FACPAC Contract Change Order

Tier 1 Project: CHHS Phase 2

**AIA**[®]**Document G709™ – 2018****Proposal Request**

Architect's Project Number: 2019111 Ph 2
Proposal Request Number: 29
Proposal Request Date: 10-29-2025

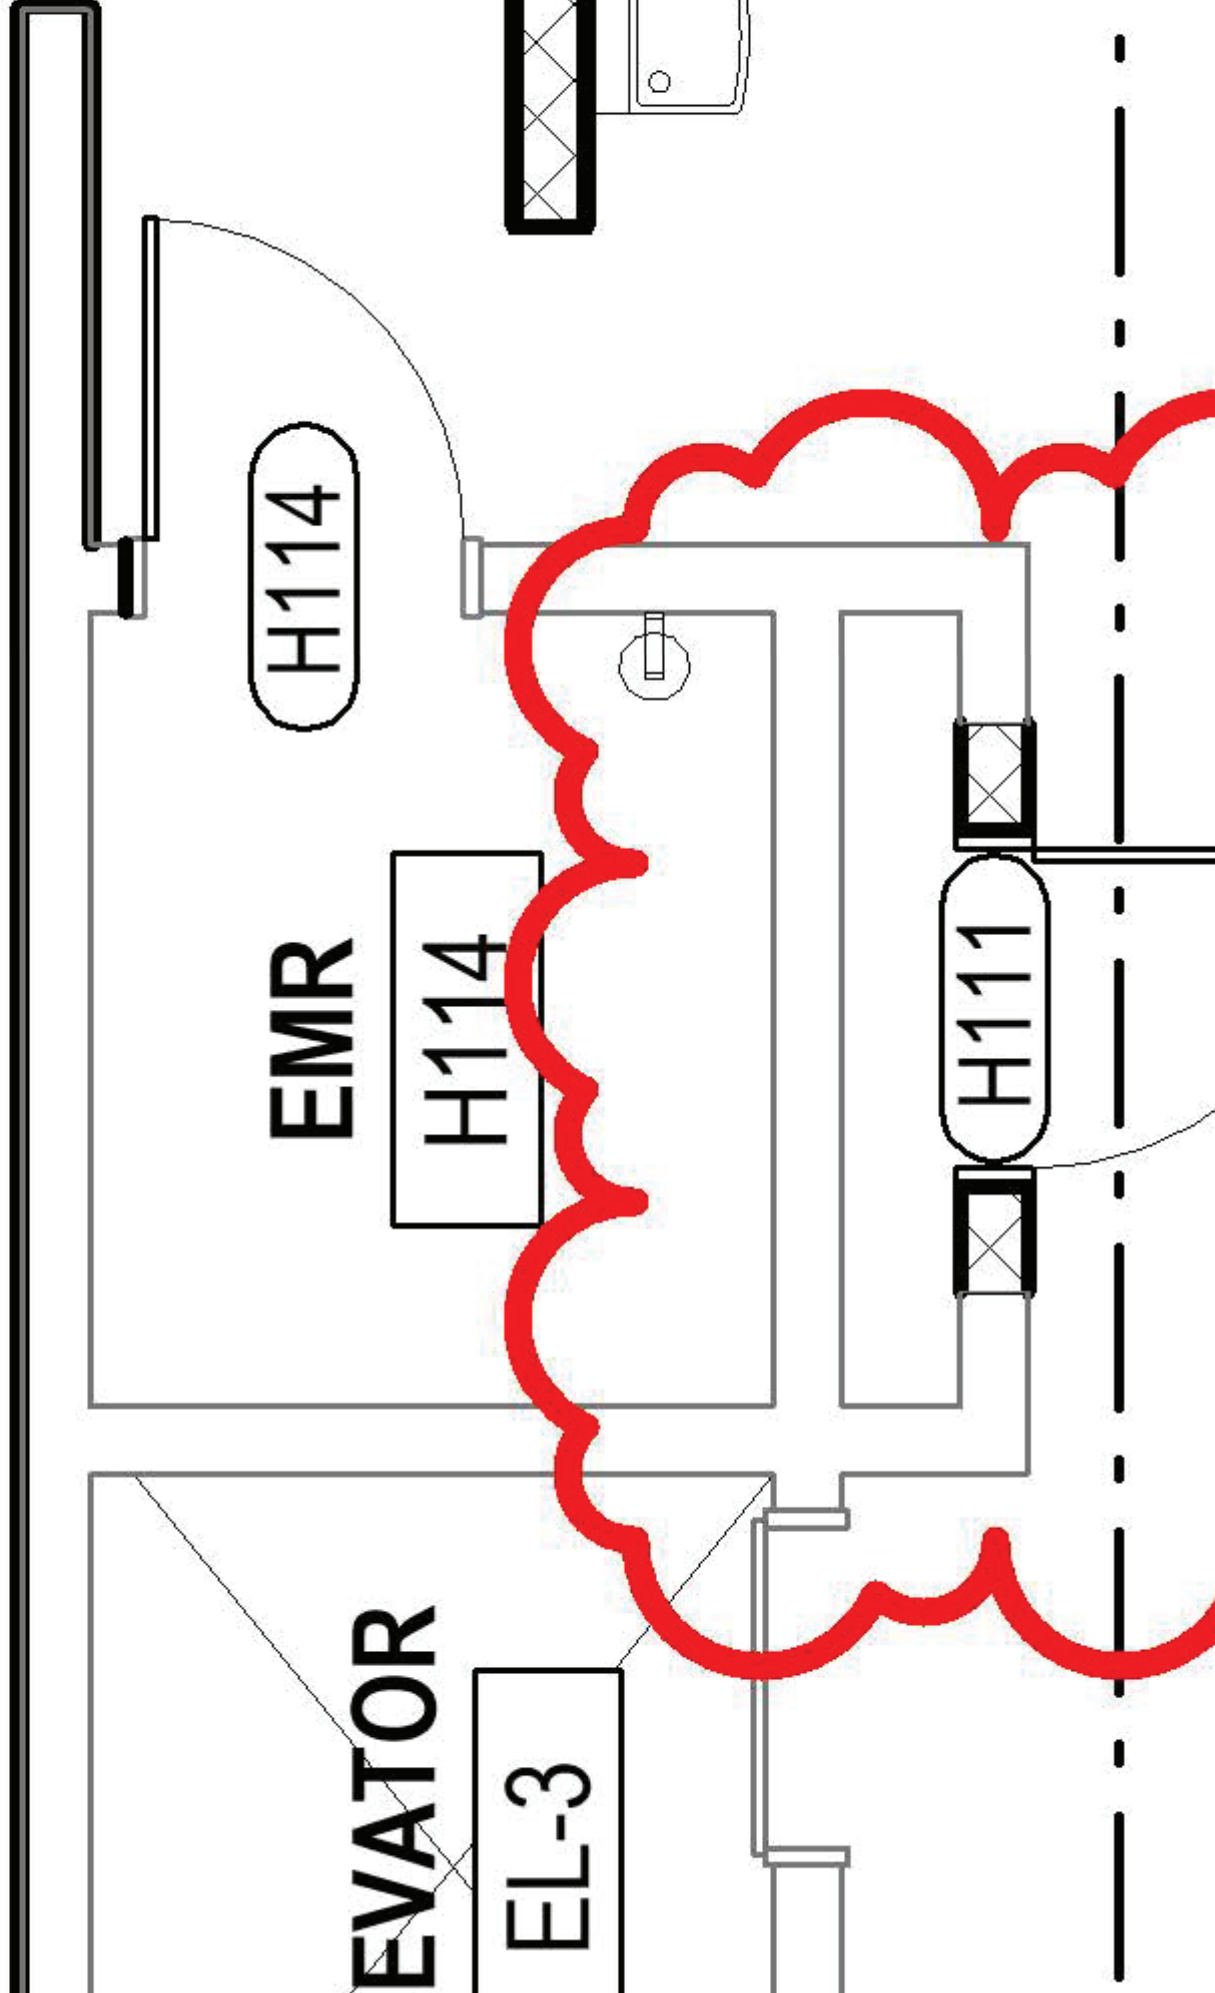
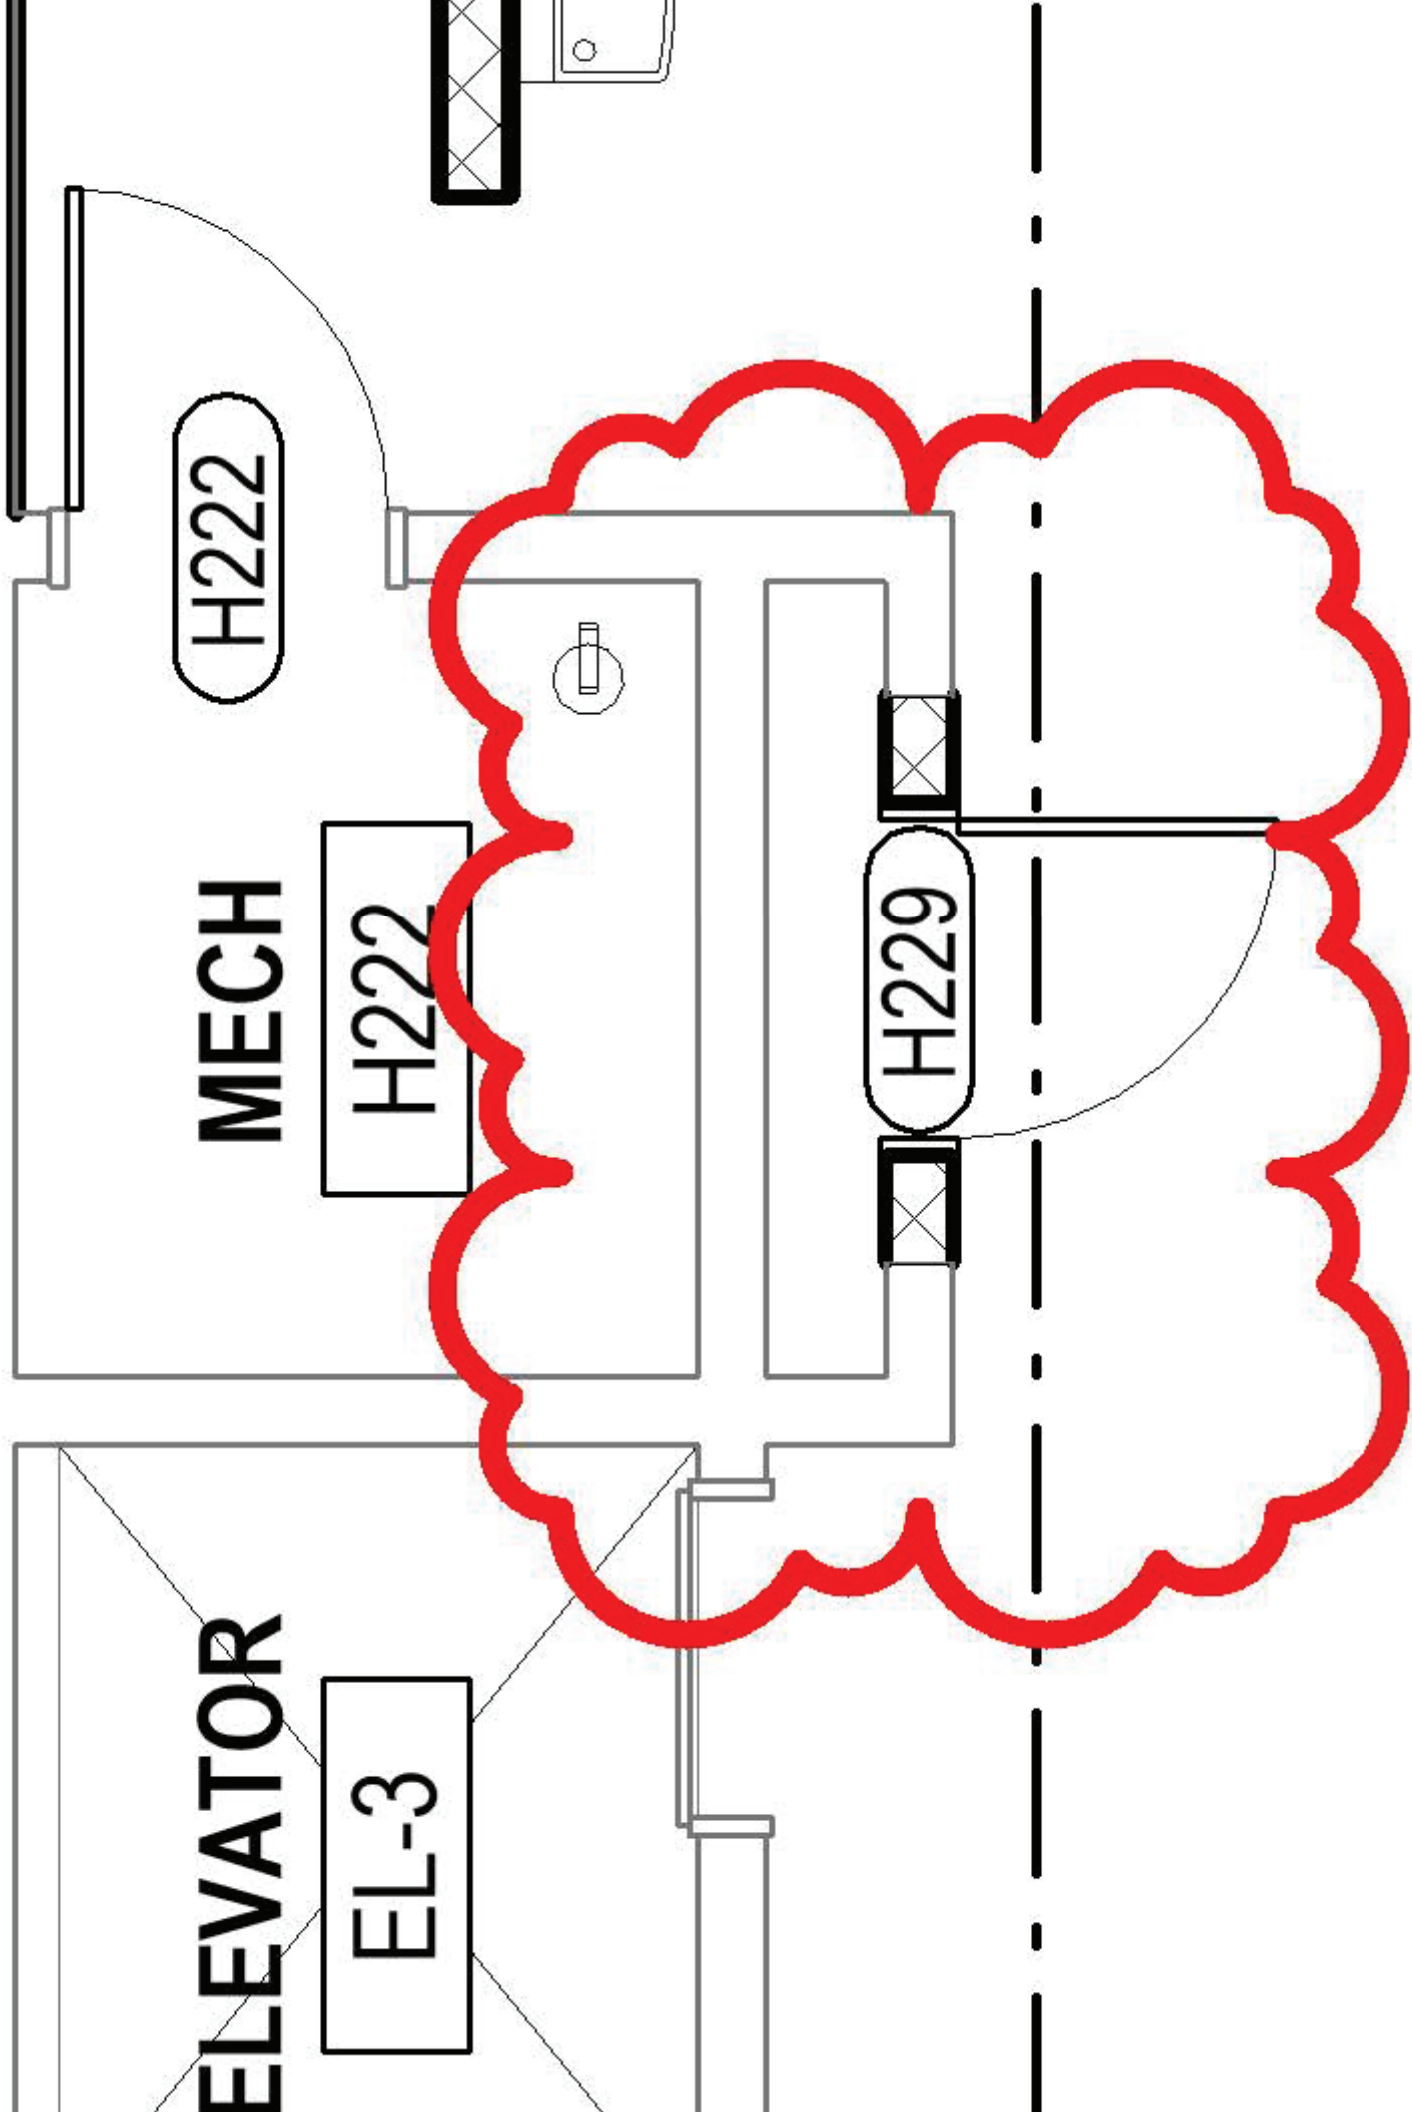
The owner would like to remove 2 display cases and turn them into closets.

Provide pricing for demolition of the sliding window, CMU below and bottom of display case. Provide a 3'-0" by 7'-2" single "Type F" wood door with hollow metal frame.

Match door hardware on H215A door. Infill with CMU as required.

Match adjacent finishes and paint interior of room P-1, add B-1 rubber base, RT-1 rubber flooring and add light fixture.
